**A G E N D A**  
**CANBY PLANNING COMMISSION**  
**REGULAR MEETING**  
**City Council Chambers**  
**Monday, September 25, 1995**  
**7:30 p.m.**

# - STAFF REPORT -

DR 95-16  
(Larios/South County Fencing, Inc.)

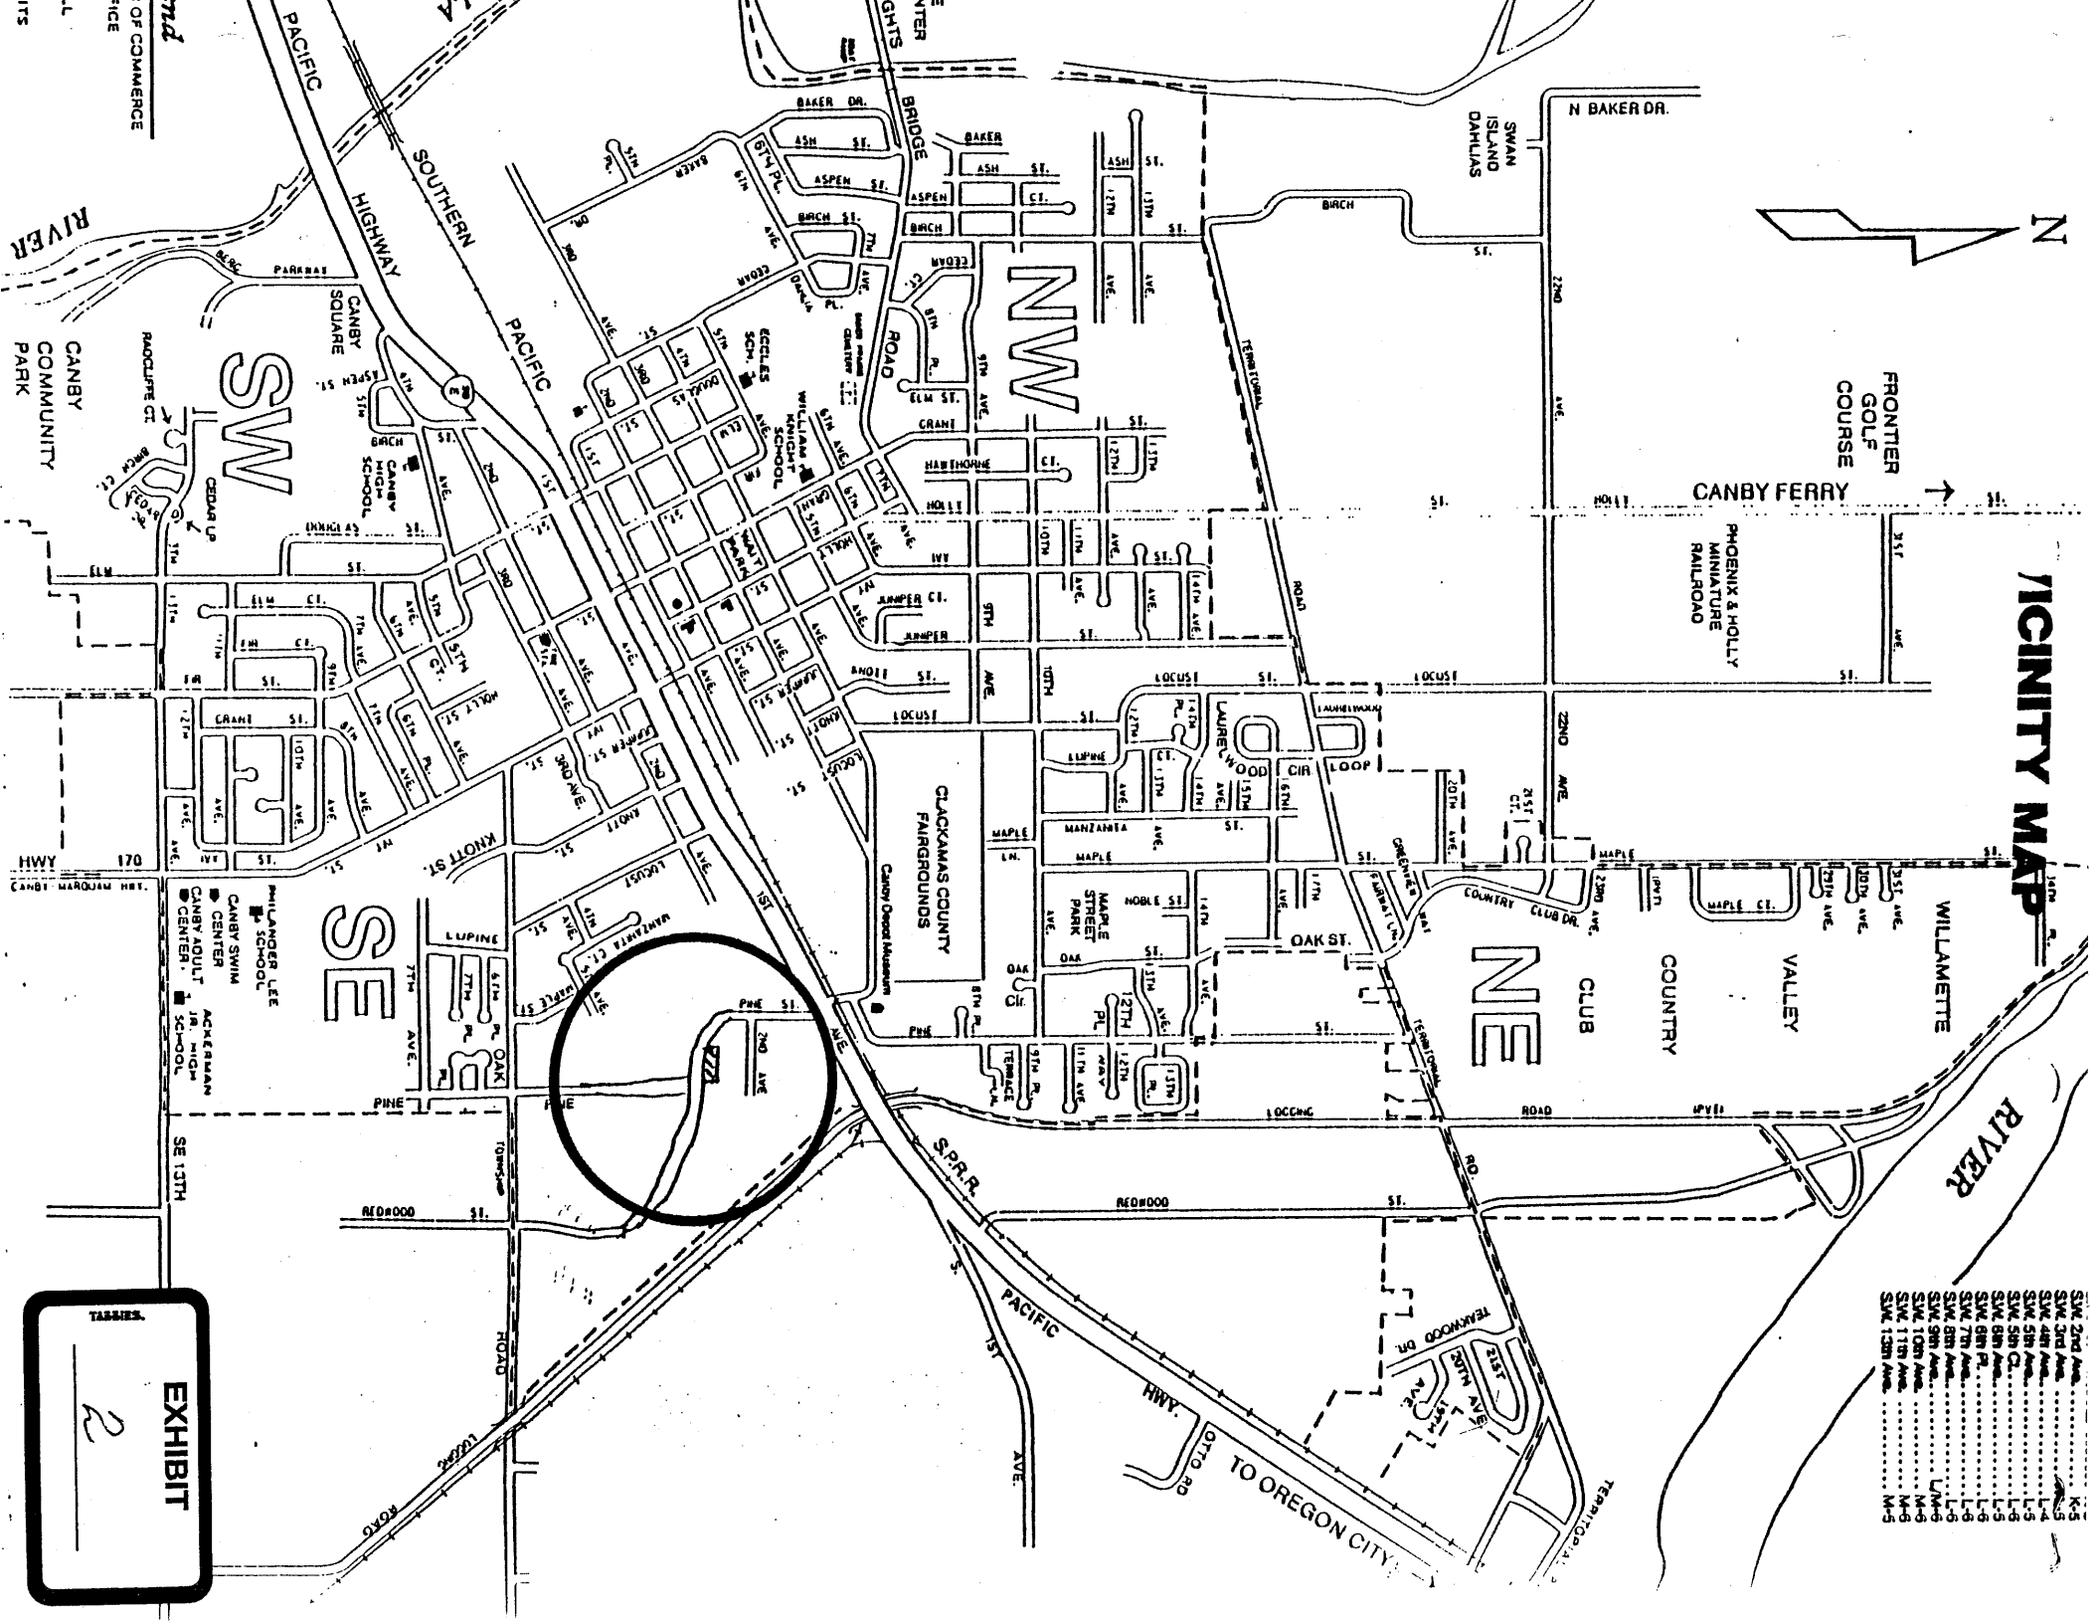
The minimum amount of landscaping required for the 22,789 square foot parcel (including five (5) feet of right-of-way) is 3,419 square feet (15%). The total amount of landscaping proposed is approximately 4,241 square feet (19.9%).

The number of parking spaces required for an industrial use such as is proposed is 5 (2.2 for the 782 square feet of office/showroom space, and 2.5 for the 2,500 square feet of manufacturing space). There are 7 parking spaces being proposed, including 1 ADA (American Disabilities Act) parking spaces (1 required). The ADA parking spaces are "van accessible" (1 required).

Pedestrian access will need to be provided from the public sidewalk to on of the south facing office entrances.

Any outdoor storage of materials abutting or facing a lot in a residential zone shall be enclosed by a site-blocking fence or berm. The fence or berm shall be so designed as to screen the storage from view from the residential zone and shall be of such material and design as will not detract from adjacent residences (16.32.030.2). It is staff's understanding that the applicant is proposing to construct a fence, however no specific plans regarding location or material has been presented in the application. The abutting or facing residential lands are to the west and the south. An eight (8) foot, cedar, sight-blocking fence extending northward from the

The extensive use of azaleas will meet the requirements of the landscaping portion of the Site and Design Review Ordinance provided that they are spaced a maximum of three (3) feet apart.

At the formula of one tree per 2800 square feet of parking/ maneuvering area, a total of 5 trees are required. There are 5 trees within or adjacent to the paved vehicle parking/ maneuvering area, not including street trees. The trees are Blue Spruces. The location of four of these trees are such that it will not interfere with access through the site. However, the Spruce that is proposed to be located on the west side of the entrance could eventually interfere partially with access onto the site. Staff recommends that this tree be replaced with a small deciduous tree. There are a few that are recommended for locations under power lines that would be suitable for this location.

3. A detailed landscape construction plan shall be submitted with the building permit. The detailed landscape plan shall show: the number of plants, plant spacing/location of planting, the type of plants, the size of plants, the schedule of planting, and irrigation plans.
4. The landscaping shall be planted at such a density so as to provide a minimum of 95% coverage of the landscape areas with vegetation, within a 3-year time period. Bark mulch and similar material shall consist of not more than 5% of the total landscape area after the 3-year period. The plant spacing and starting plant sizes shall meet the ODOT plant spacing/starting size standards. The spacing requirements for the plants to be used in the landscaping are as follows:

5. An additional three (3) Cleveland Norway Maples shall be planted between the entrance and the exit. These trees are to be no closer to the access drives than fifteen (15) feet, and shall be a minimum of thirty-five (35) feet from each other and shall be planted twelve (12) feet behind the S.E. 3rd Avenue curb, and shall be at least 2" caliper (2" at a 4-foot height) trees when planted.
6. The Blue Spruce proposed on the west side of the entrance shall be replaced by a tree selected from PGE's "Guide To Selecting Street Trees". The tree shall be at least 2" caliper (2" at a 4-foot height) trees when planted.
7. A walkway connecting the sidewalk along S.E. 3rd Avenue to one of the south-facing office entrances shall be provided.
8. A solid, sight-blocking, cedar fence, eight (8) feet in height, shall be provided around all outdoor storage areas.
